CITY OF PORTLAND, MAINE
PLANNING BOARD

Project Name: The Forefront at Thompson's Point Project Level III Site Plan and Subdivision Application

PLANNING BOARD REPORT PORTLAND, MAINE

The Forefront at Thompson's Point
Level III Site Plan and Subdivision Review
2015-133 (Subdivision) & 2015-159 (Level III Site Plan)
Chris Thompson, Forefront Partners I LP

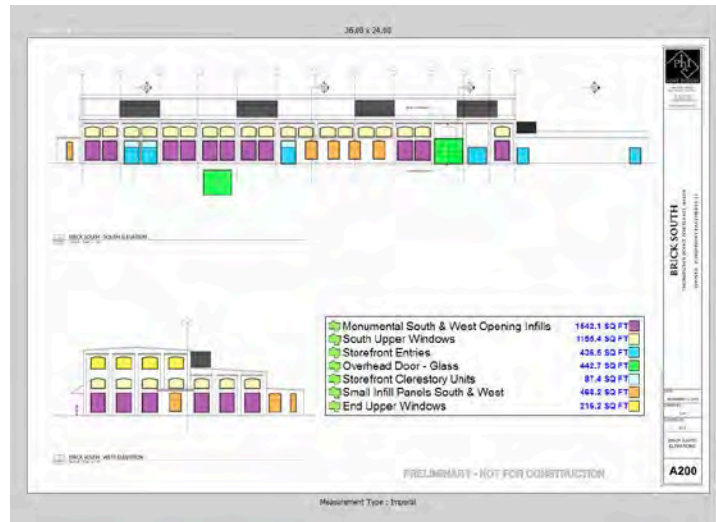
- Figure I-2. A requirement for continuous sidewalks on both sides of the collector road. There is a sidewalk planned for full length of the western side of the road, and a facing sidewalk that begins partway in to the first lot on the eastern side (suburban propane/Lots 14 & 15/location of Building F1/H on the overall site plan). The Level III site plan does not include the eastern sidewalk. Mr. Errico’s comments: *The current Level III Site Plan for the Brick North/South phase does not include a sidewalk on the east side of Thompson’s Point Road Extension. I support a waiver for building this sidewalk under this phase with the condition that the applicant will be responsible for construction of a sidewalk (and any necessary improvements to the Thompson’s Point Road Extension) during the construction of Building H/F1, as depicted on the overall site plan.*

- Figure I-2. A requirement for a minimum roadway width of 40 feet for collector roads. The road design shows a range of 30-39 feet. Mr. Errico notes in his comments that he is comfortable with the proposed roadway cross-section.

- Figure I-2. Requirement for a minimum esplanade width of 5 feet for collector roads. Plan depicts a 4 foot esplanade.
